ORINDA WATER TREATMENT PLANT DISINFECTION IMPROVEMENTS PROJECT

Final Supplemental Environmental Impact Report
SCH #2019080297

Prepared for
East Bay Municipal Utility District

Figure 3

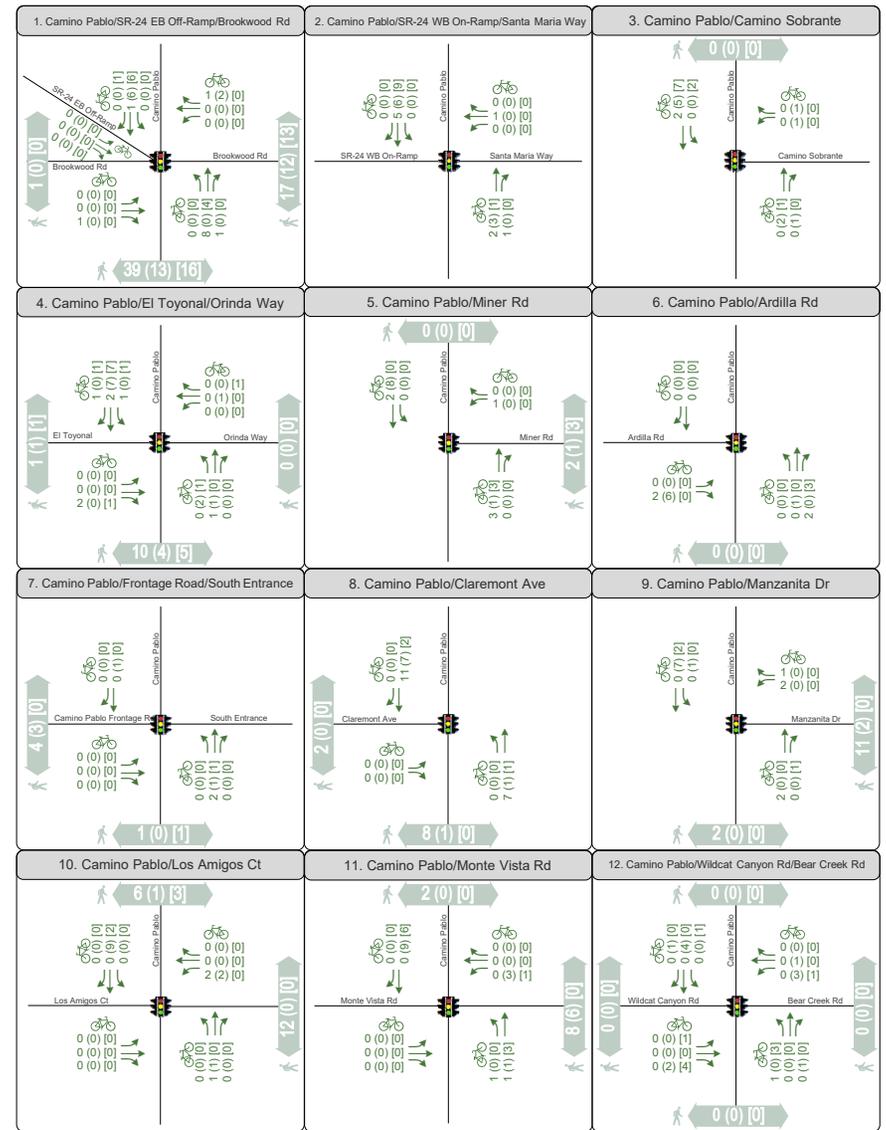
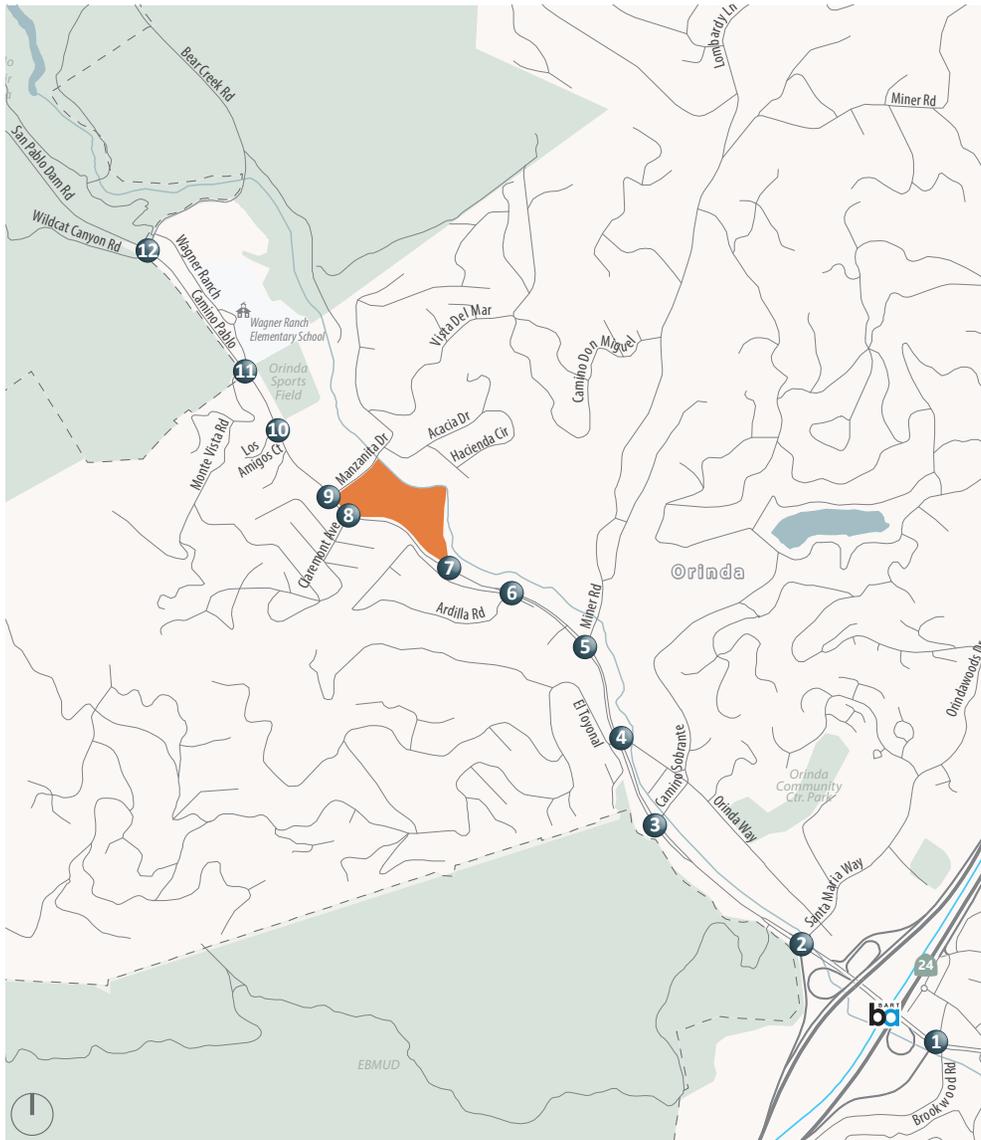
Comment: Several of the traffic volume figures (e.g., Figures 3, 7, and 9) in the Traffic and Circulation Technical Report Orinda Water Treatment Plant Disinfection Improvements Project (Fehr

Figures 3, 4, 7, and 9 of the Traffic and Circulation Technical Report (Draft Supplemental EIR Appendix G) contained a printing error that made those figures difficult to read. The printing error was corrected and the figures were posted to the Project's website at <https://www.ebmud.com/orwtpimprovements> on September 3, 2020. The corrected figures are also included in this chapter.
